National Spent Nuclear Fuel Program

Review of Flow Models in GOTH_SNF for Spent Fuel MCO Calculations

September 2003

**DOE/SNF/REP-087
Rev. 0**

Figure 1. Schematic showing location of fuel rings. (Figure 4-2, p. 4-4 of Reference 1.)

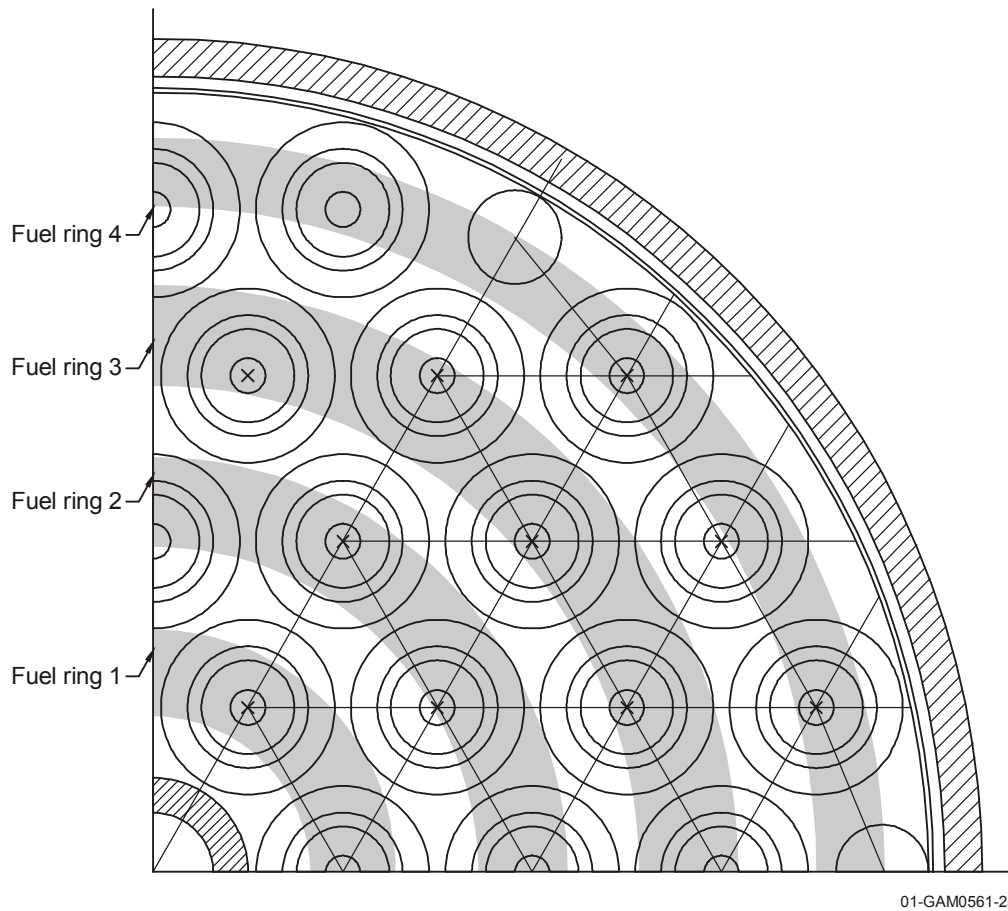
Figure 1 shows a schematic of the fuel elements in the basket. In GOTH_SNF, the solid metal is combined into a series of rings, which are shaded grey in the figure. The various flow areas are combined into annular gas channels represented by the portions that are not shaded in Figure 1. The unshaded area between fuel ring 1 and fuel ring 2 is called "Gas Channel 3." There are several different types of flow areas. Figure 2 shows a schematic of the three different types of flow areas that are present in Gas Channel 3 (the hatched area in this figure is actually in Gas Channel 4). These three types of flow areas also make up Gas Channels 2, 4, and 5. These flow areas are also important in Gas Channel 6. The largest of the three flow areas is the one between the fuel elements shaped like a trefoil. In Reference 1, it is called "triangular pitch" element. The other two flow areas are the annulus between the inner and outer fuel element and the central hole in the middle of the inner element.

Figure 2. Flow area (hatched area) formed by fuel triangular pitch arrangement. (Figure 4-1, p. 4-2 of Reference 1.)

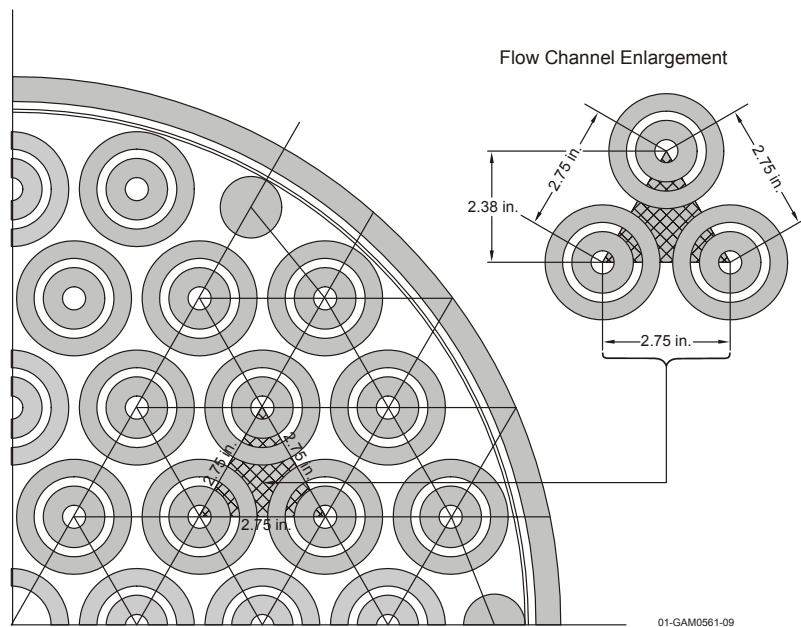
Figure 2 is slightly misleading. It is supposed to show a set of flow areas that belong to Gas Channel 4. The figure seems to suggest that the 1/6 segments of the inner and annular flow areas of all three fuel elements bounding the triangular pitch flow area are combined with the triangular pitch flow area. This area creates a total flow area that is then multiplied by the number of triangular pitch areas in each ring to create the gas channel. This is not correct. Instead, the inner and annular flow areas for each fuel element are used in total. This can best be explained by examples starting from the inside and working out. Although Figure 1 and Figure 2 (for that matter, Figure 3) show the fuel elements in a quarter circle, a 1/6 circle segment has lines connecting the fuel elements. The arrangement of fuel elements in the fuel basket is composed of six identical segments, each 1/6 of the circle. In Figure 2, one can see that there are two fuel elements (actually two half fuel elements) in the 1/6 of a circle segment in the inner slant row almost touching the inner support pipe. These two half fuel elements are multiplied by 6 to produce six fuel elements in Gas Channel 2. In addition, there is a single triangular pitch flow area between the inner support pipe and these two half elements. Therefore, Gas Channel 2 also contains 6×1 triangular pitch elements. The next layer of fuel elements (the next slant row) in Figure 2 contains one complete fuel element and two half elements in the 1/6 of a circle segment. In addition, there are three triangular pitch areas in the 1/6 of a circle element between the first and second slant rows. Figure 3 shows a schematic that includes a triangular pitch flow area from Gas Channel 3. The combination of the fuel elements and triangular pitch areas multiplied by 6 is Gas Channel 3. Thus, Gas Channel 3 is composed of $6 \times 3 = 18$ triangular pitch elements plus $6 \times (1 + 1/2 + 1/2) = 12$ each of the fuel element inner and annular flow areas. The constitution of Gas Channels 4 and 5 can be calculated by the same method. Because the insides of the fuel elements are all allocated to Gas Channels 2–5, Gas Channel 6, which is between the outermost layer of fuel elements and the inside of the basket shroud, does not contain any contribution from flow inside the fuel elements.

Figure 4. Comparison of pressure difference vs average flow velocity for the three different approaches for calculating flow.

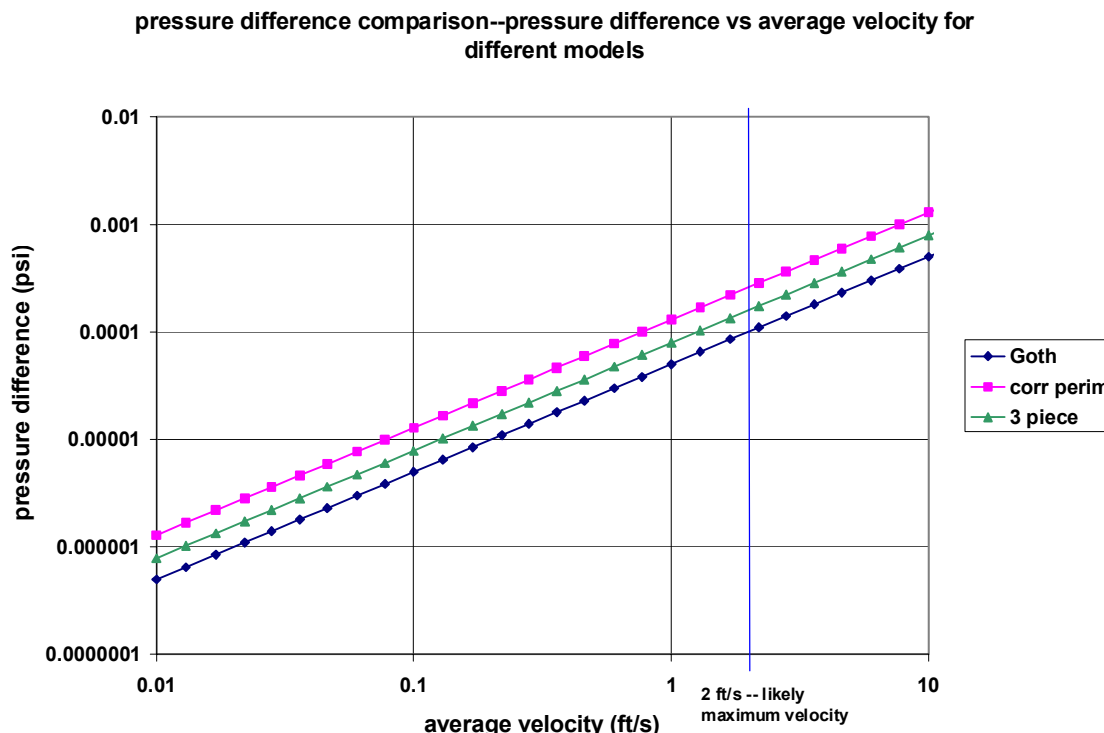
Figure 4 shows a comparison of the pressure differences generated by the three different approaches to calculating the flow as functions of the average velocity. In the figure, Version 2 is the line marked "corr perim" (which stands for "corrected wetted perimeter"), and the three different flow areas approach is the line marked "3 piece." In the laminar range, the pressure drop is proportional to the average velocity for each of the three approximations. If one does the algebra, it can be seen that the pressure difference for a given average flow velocity is inversely proportional to the square of the hydraulic diameter. The approach used by GOTH_SNF has the highest hydraulic diameter (0.084 ft) and, therefore, has the lowest pressure drop for a given average velocity. The Version 2 approach has the lowest hydraulic diameter (0.053 ft) and, therefore, has the highest pressure drop for a given velocity. The square of the ratio of the GOTH_SNF hydraulic diameter to that of Version 2 is ~2.6. This is the same as the ratio between the velocities at any given pressure drop as shown in Figure 4. The three separate flow areas approach creates a curve of pressure drop versus average velocity in the laminar range that corresponds to an apparent average hydraulic diameter of 0.0673 ft. Therefore, this approach gives results in the laminar range that are between the other two.

After analyzing the effect of the three different approaches on the curves of pressure difference versus the average velocity, the most important question is what difference does it make? To answer that question it is recommended that a test in GOTH_SNF be run doing the following:

Select a MCO case that represents an important decision point. Such a case would be one for which, if the results were to change in the “wrong” direction, the conclusions about the safety of the MCO would be different. For this case, change the hydraulic diameter from the GOTH_SNF value of 0.084 ft to the value that represents Version 2 (0.053 ft—the lowest of the three values) and run the MCO case again. Gas Channels 2–5 (and perhaps 6 as well) are all subject to corrections based on having this more complex geometry. Each of the gas channels will have a different correction factor for its hydraulic diameter. As a first cut, one could try multiplying the hydraulic diameters of all Channels 2–6 by the same factor (0.053/0.084). See if the results of the MCO case using the hydraulic diameters with this

Figure 5. Comparison of flow area velocities in different flow areas vs average velocity for three different flow area flow calculations.

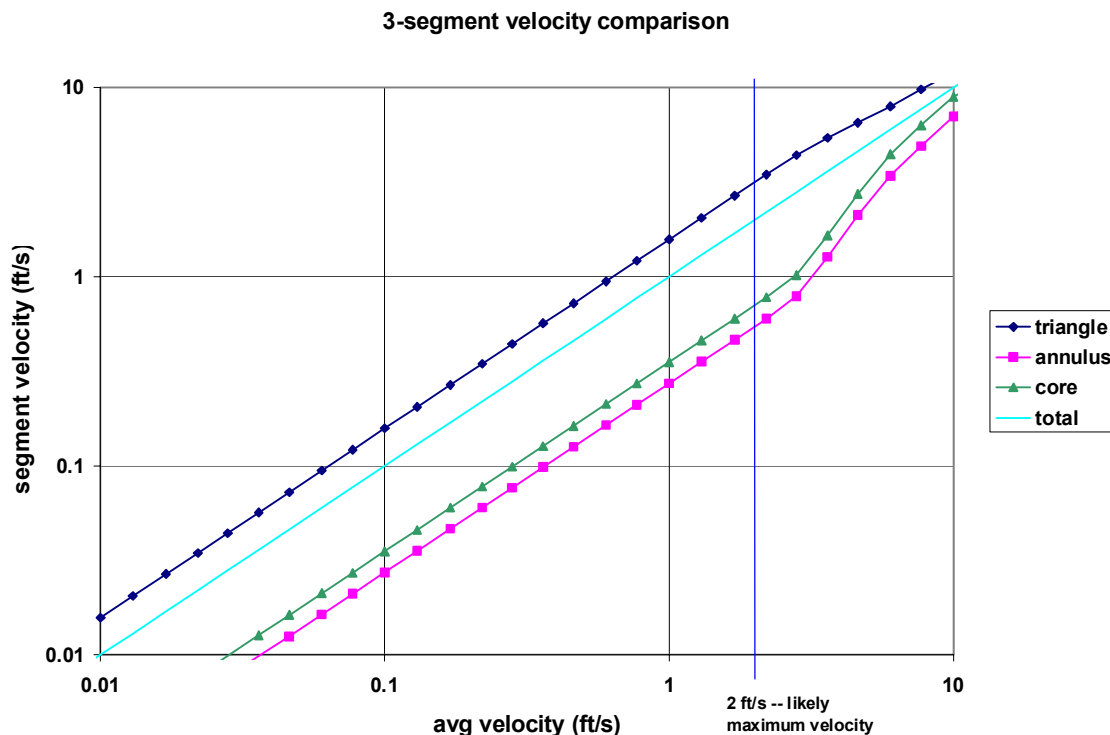
Figure 5 shows the velocities in the three different flow areas for the three separate flow areas approach compared to the average velocity. The effect of the three different hydraulic diameters is obvious. The ratio of the velocity in the triangular pitch area to that in the annulus between the inner and outer elements is the largest. The combination of different hydraulic diameters and different flow area velocities leads to different locations for the beginning of the laminar to turbulent transition. However, none of the flow areas reaches turbulent transition before the maximum velocity of 2 ft/s. If one uses the apparent average hydraulic diameter inferred from analysis of the three separate flow areas model in the previous paragraph and calculates a curve of pressure drop versus velocity in the turbulent range, the pressure drop for a given average velocity is only ~12% lower than the value given by calculating the flow in the three different flow areas and adding them up.
